CITY OF FORT COLLINS

ADDENDUM No. 5

CABLE 27 STUDIO AT CITY HALL – PHASE 1

Floor Plan Sketch  
Section Sketch

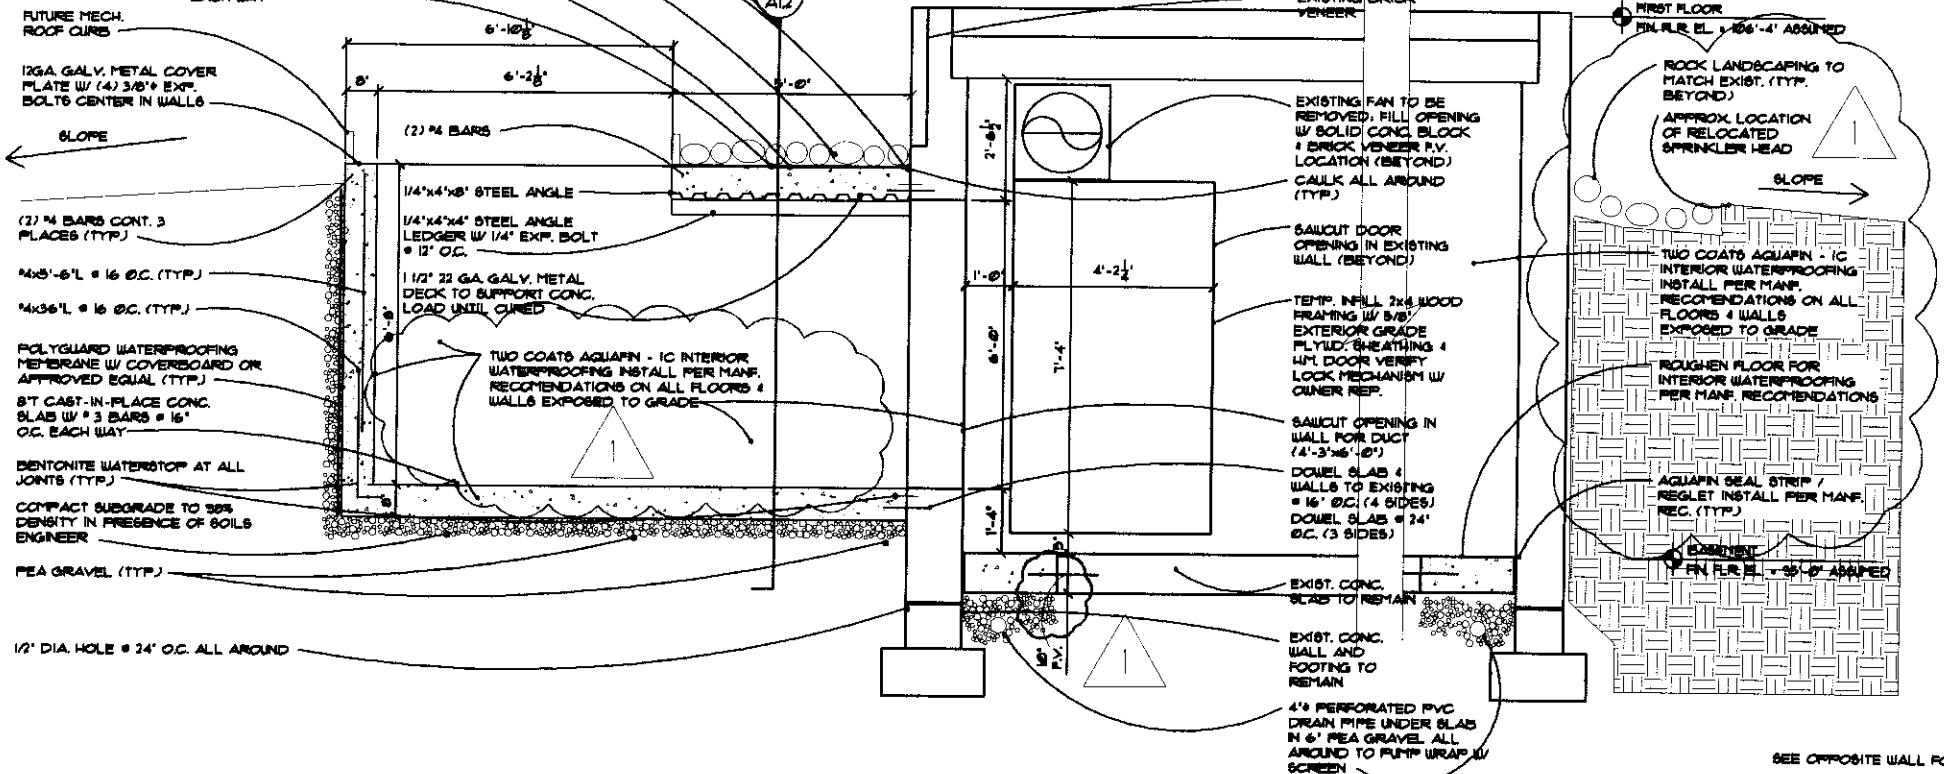
Revision: Remove exterior perimeter drain and with interior perimeter drain and waterproofing. See attached sketch.

Revision: Remove exterior perimeter drain and replace with interior perimeter drain and waterproofing. See attached sketch.
